Project Name:	Prelim Design for New Core Area Collector Road (Phase 1)
Addendum Number:	3
Project ID:	2026-RFP-016

Addendum 3 is hereby issued to amend the *2026-RFP-016 Prelim Design for New Core Area Collector Road (phase 1)* changes outlined in this addendum shall take precedence over the original document.

Figure A – Intersections to be included in analysis

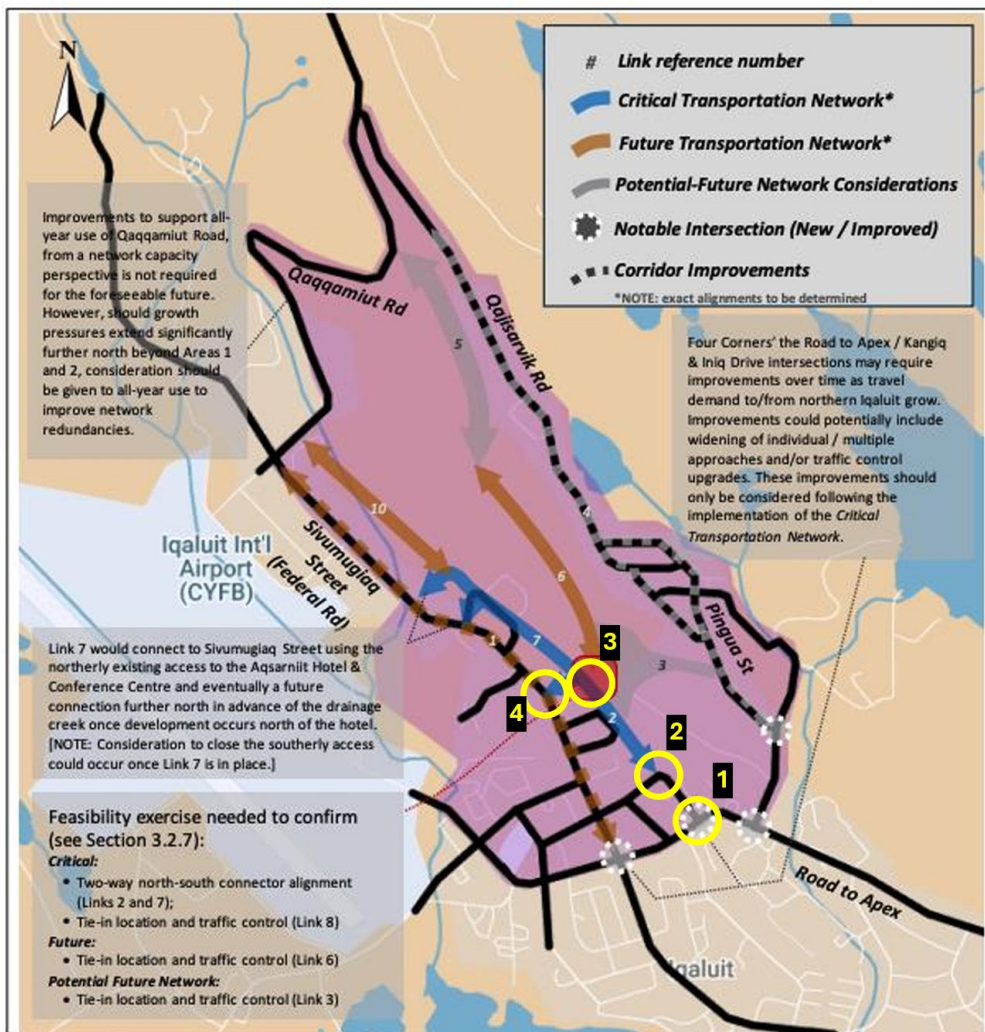
The RFP requires that the consultant conceptually identify the traffic control needs (including signalization) across the three corridor alternatives. Is the consultant required to use traffic count data to forecast future traffic volumes within the study area? If so, please identify additional scoping information such as the intersections to be included in the forecast analysis and whether there are any future development areas that are not identified within the existing background traffic study reports.

The information below outlines the City's expectations for conceptually identifying the traffic control needs for the new Core Area collector road:

- Use existing traffic count data:
 - TMP (2021)
 - High School Intersection Study (2023) - document uploaded to [//plan.iqaluit.ca/en/pages/bypass-road](https://plan.iqaluit.ca/en/pages/bypass-road)
 - TIS - TBG Mixed-Use Development (2024)
- Forecast future traffic volumes within the Study Area;

- Intersections to be included in the forecast analysis are shown in **Figure A**:
 - 1 - Niaqunngusiariaq Road @ Kangiq and Iniq
 - 2 - Kangiq and Iniq @ Nunavut Drive
 - 3 - New Link 2, 6, 7 & 8 Intersection on Inuit Owned Land
 - 4 - Link 8 @ Sivumugiaq Street
- There are no additional future development areas that need to be considered for this analysis. See the Transportation Master Plan (2021) for future transportation demand forecasts.
